**SYDNEY WEST CENTRAL PLANNING PANEL
COUNCIL ASSESSMENT REPORT**

Panel Reference	2016SYW157 DA
DA Number	DA/696/2016
LGA	City of Parramatta
Proposed Development	Construction of a mixed use development comprising 275 residential apartments and 7 commercial tenancies with building heights ranging between 4 to 10 storeys, 370 car parking spaces, public domain works and landscaping.
Street Address	6-8 Baywater Drive, WENTWORTH POINT NSW 2127 (Lot 18 DP 270113)
Applicant/Owner	Tier Architects / Homebush Bay Holdings Pty Ltd
Date of DA lodgement	2 August 2016
Number of Submissions	Public Submissions (3)
Recommendation	Deferred Commencement Consent
Regional Development Criteria (Schedule 4A of the EP&A Act)	Pursuant to Clause 3 of Schedule 4A of the Environmental Planning and Assessment Act 1979, the development has a capital investment value of more than \$20 million.
List of all relevant s79C(1)(a) matters	<ul style="list-style-type: none">• Environmental Planning and Assessment Act and Regulations• SEPP (Building Sustainability Index: BASIX) 2004• SEPP (Infrastructure) 2007• SEPP (State and Regional Development) 2011• SEPP (Sydney Harbour Catchment) 2005• SEPP No. 55 (Remediation)• SE

Figure 6. Extract from Homebush Bay West DCP 2004 Amendment 1 (subject site outlined in red).

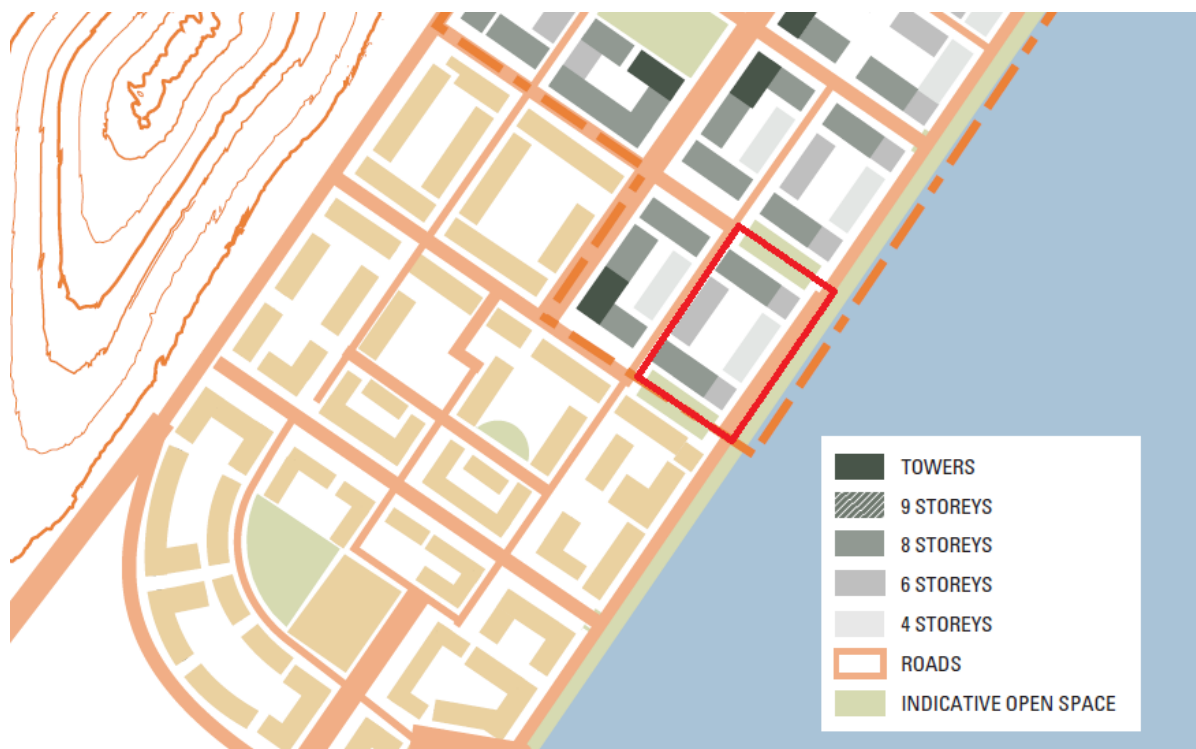
Clause 5.3.2 of Homebush Bay West DCP Amendment 1 outlines the allowable building heights for the site. The DCP allows 4 - 8 storeys on the site in accordance with the figure above.

The breach of the height limit on the western block is considered to be acceptable as the proposal will still generally read as a 6 storey building due to the Marine Parade reaching a high point to the front of the block. However, the North Block will appear up to 10 storeys in height when viewed from the north (see Figure 7 below) with the top floor sitting a full storey higher than south block. The HBW DCP clearly anticipated north/south symmetry on the site (See Figure 6 above).

Figure 7. Proposed Northern Elevation with number of storeys above ground level as defined by HBW DCP.

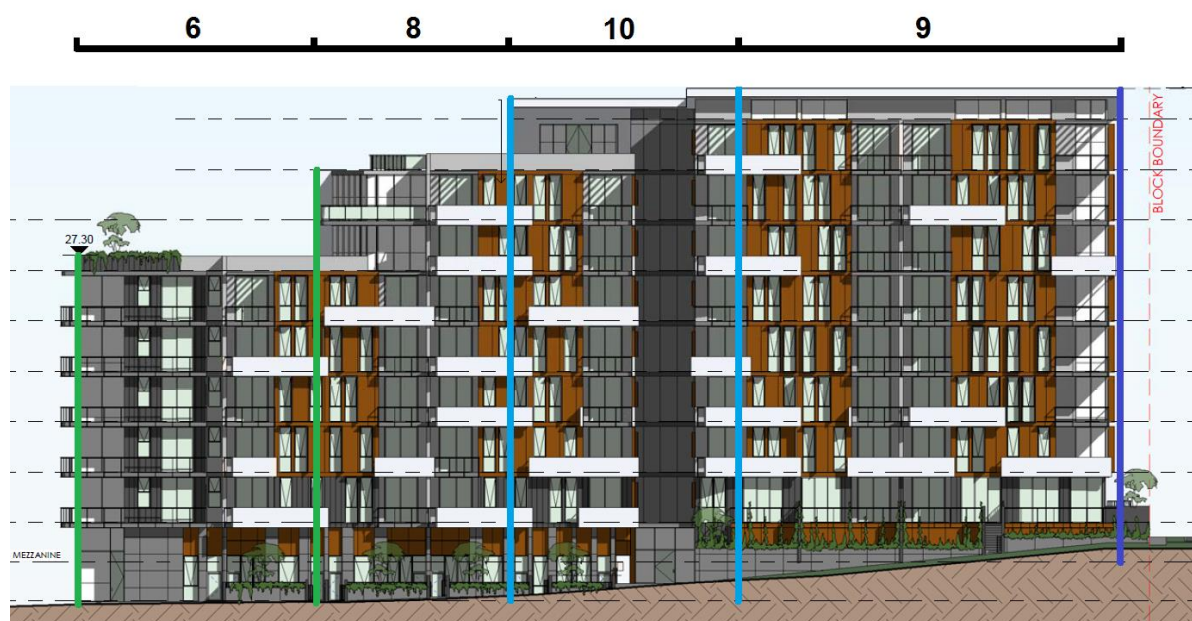
Based on the definition of storeys in the DCP and the proposed site levels the proposal breaches the height limit in several locations (see table below).

DESIGN CRITERIA	ALLOWED	PROPOSED	COMPLY?
West Block	6	6 - 7 (inc. parking levels)	Part
East Block	4	4	Yes
North Block	6-8	6 – 10 (inc. parking levels)	Part
South Block	6-8	6 – 8	Yes

The ground floor level, which is composed primarily of car parking, is more than 1200mm above ground level for some of the blocks and as such counts as a storey in the above table. While this breach of the control could be resolved by setting the parking level further underground that is not possible on the site due to contamination and water level constraints. While not as wide spread as the alternative floor space interpretation outlined above, there are several examples of development applications in the area in which such ground levels were not included in the height assessment².

Subject to removal of the top floor of North Block the proposal is considered, on balance, to be in keeping with the density of development anticipated for the site for the following reasons:

- Removing the top floor would be more in keeping with the block pattern anticipated for the site in the HBW DCP (see Figure 6 above).
- Removing the top floor would reduce overshadowing of the central courtyard and units facing it which have limited solar access. This issue was raised as a concern by both DEAP and JRPP.

As such a deferred commencement condition is included requiring the top level of North Block be removed. The condition will require that the resulting roof form be generally in keeping with the roof form of the top level of the South Block.
